**ADMINISTRATIVE AMENDMENT**  
FILE # 12-11112 PROJECT # 1022445  
NEW EXTERIOR PAINT COLOPS, REPLACE  
PHARMACY DRIVE THRU BUS AND SIGNAGE  
NEW PHARMACY PICK-UP SIGN  
APPROVED BY: [Signature] DATE: 10-31-17

|                                                                                                   | <b>AA - SITE PLAN FOR BUILDING PERMIT (OVERALL)</b> | <b>2010077-SPB</b> |

Walmart  
ALBUQUERQUE, NM  
STORE NO: 5675  
JOB NUMBER: 96542672  
ELEVATIONS

FOOTHILLS, S.C.  
MENAUL AND JUAN TABO  
Pylon Sign Elevations  
and Bale/Pallet Enclosure

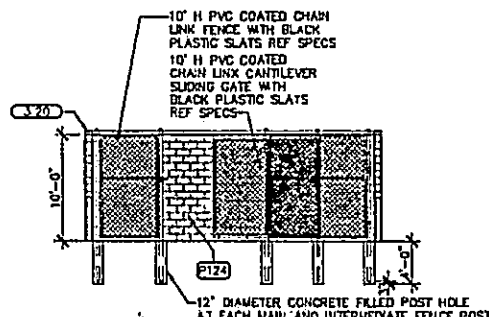
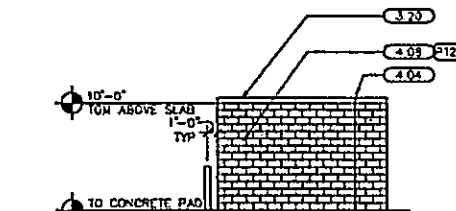
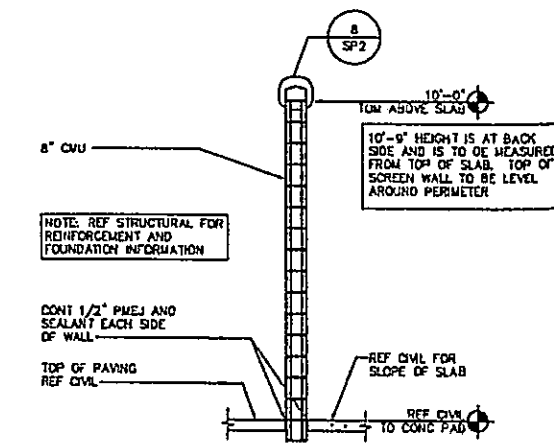
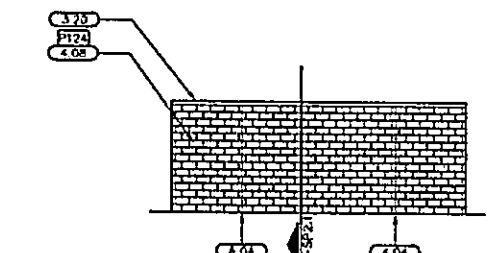
**ADMINISTRATIVE AMENDMENT**  
FILE # 12-11112 PROJECT # 1022445  
10' high pallet enclosure  
445 sq ft  
APPROVED BY: [Signature] DATE: 7/11/12

| NO. | DATE     | REVISIONS                               | BY  |
|-----|----------|-----------------------------------------|-----|
| 1   | 04-09-12 | ADD BALE AND PALLET RECYCLING ENCLOSURE | JCH |
